Access Compliance Report

Public Rights-of-Way

(Curb Ramps)

Intersection ID: 21549	Main Street: S_TRYON_ST	Cross Street: SANDY_PORTER_RD	Location: NE
ADA ID: 3AD05219923E	Ramp Type: Perp	Initial Pass/Fail: Fail	Overall Compliance: No
		Severity Score: 25

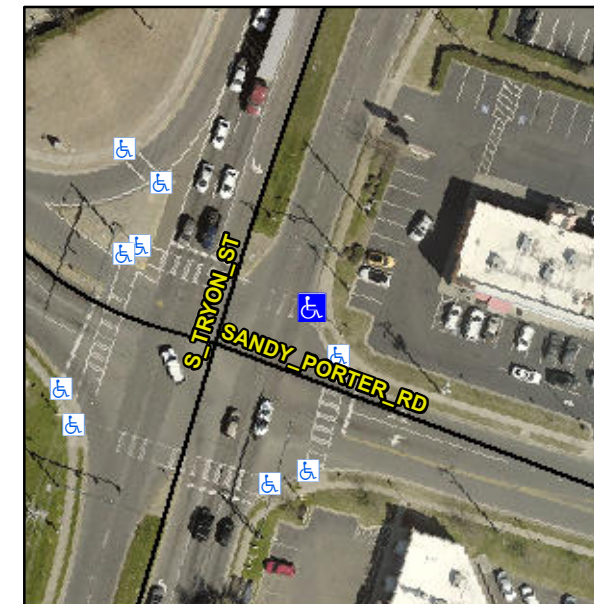
Not Found, R304.2.2, R304.5.3

Compliance	Description	Data	Compliance	Description	Data
N/A	Ramp Length (in)	95.0	No	Ramp Slope (%)	8.7
Yes	Ramp Width (in)	48.0	No	Ramp XSlope (%)	5.1
N/A	Flare Type LT	N/A	N/A	Flare Type RT	N/A
N/A	Flare Slope LT (%)	N/A	N/A	Flare Slope RT (%)	N/A
N/A	Flare Traversable LT?	N/A	N/A	Flare Traversable RT?	N/A
N/A	Landing Length (in)	N/A	N/A	DWS Provided?	N/A
N/A	Landing Width (in)	N/A	N/A	DWS Contrast?	N/A
N/A	Landing Slope (%)	N/A	N/A	DWS Length (in)	N/A
N/A	Landing X Slope (%)	N/A	N/A	DWS Full Width?	N/A
N/A	Landing Curb? (Y/N)	N/A	N/A	DWS Offset (in)	N/A
N/A	Shared Landing?	N/A			
N/A	Gutter Ponding?	N/A	N/A	Gutter Slope (%)	N/A
N/A	Gutter Lip Ht (in)	N/A	N/A	Gutter X Slope (%)	N/A
N/A	Painted X Walk1?	Yes	N/A	Painted X Walk2?	N/A
	X Walk 1 Direction	To NW		X Walk 2 Direction	N/A
N/A	X Walk 1 Width (in)	112.0	N/A	X Walk 2 Width (in)	N/A
	X Walk 1 Slope (%)	0.4		X Walk 2 Slope (%)	N/A
	X Walk 1 X Slope (%)	0.8		X Walk 2 X Slope (%)	N/A

Remove & Replace Entire Ramp.
